SECTION 6B

CLUTCH

Service procedures and adjustments are essentially the same as written in the 1961 Shop Manual.

Fig. 6B-1—Clutch Linkage

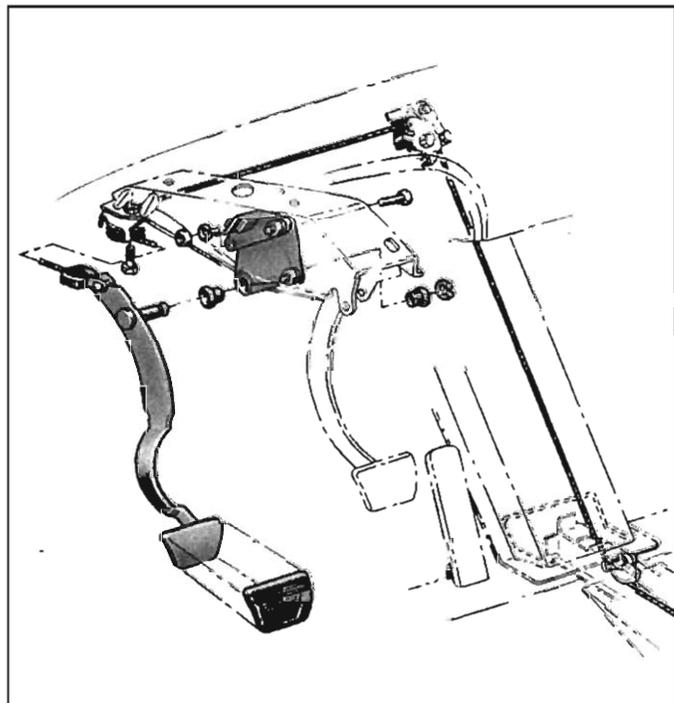
The clutch pedal over-center spring was eliminated on late 1961 and 1962 models (fig. 6B-1).

Fig. 6B-3—Hi-Performance Clutch

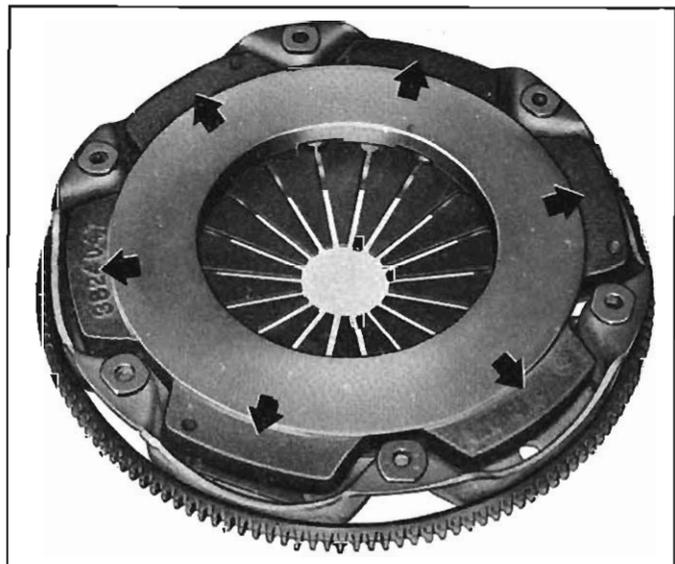
This clutch has a pearlitic malleable or nodular iron pressure plate identified by 6 large cast lugs on the outer diameter (fig. 6B-3) and must be used on this engine. The complete assembly may be used with the super-turbo-air engine.
